Docket Number:	22-BSTD-04
Project Title:	2022 Energy Code Photovoltaic and Battery Storage Cost Effectiveness Determinations
TN #:	255062
Document Title:	C Note responses to Stakeholder comments
Description:	N/A
Filer:	Muhammad Faisal Saeed
Organization:	California Energy Commission
Submitter Role:	Applicant
Submission Date:	3/14/2024 8:18:40 AM
Docketed Date:	3/14/2024

Re: Response to BPi, SunPower, and Powertree Services 3/5/24 comments to Docket No. 22-BSTD-04 on Application for Photovoltaic System Determination for the Benjamin Project in Accordance with Section 10-109(k) of the Building Standards

Section B. C Note's responses (in RED) to BPi's 3/5/24 public comments on the Benjamin Project PV Determination request filed in CEC Docket No. 22-BSTD-04

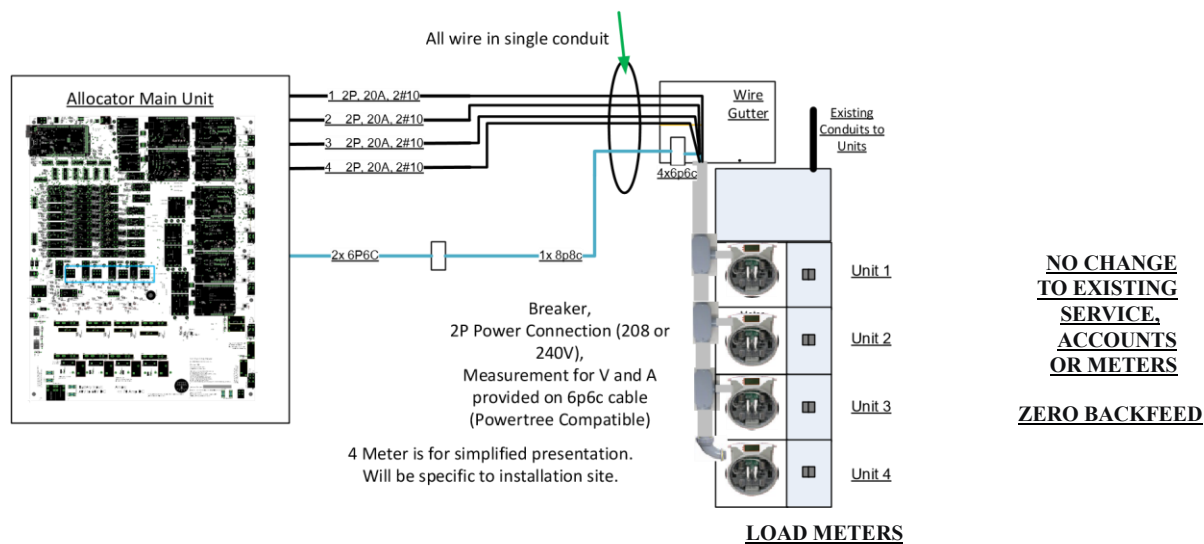
- 4. The Solar array due to the fixed sizing and lack of controls matching generation delivery to load only achieves a fraction of its potential value and will back feed, at lower compensation rates, a significant and variable amount of its production. Powertree's study on live sites has shown that a fixed array will have a self-consumption rate of between 24% and 47% depending on the array size and tenant work style. Larger arrays and away from home workers have lower self-consumption rates. This reduces the value achievable from a system. By contrast, systems with storage and controls can achieve self-consumption rates in the high 90%+ range.

The Benjamin's PV designs/bids were based on standard, common PV practices. Lodi Utility's compensation rates are among the most generous in the state of California at this time and were factored into the CEC algorithm's modeling and analysis.
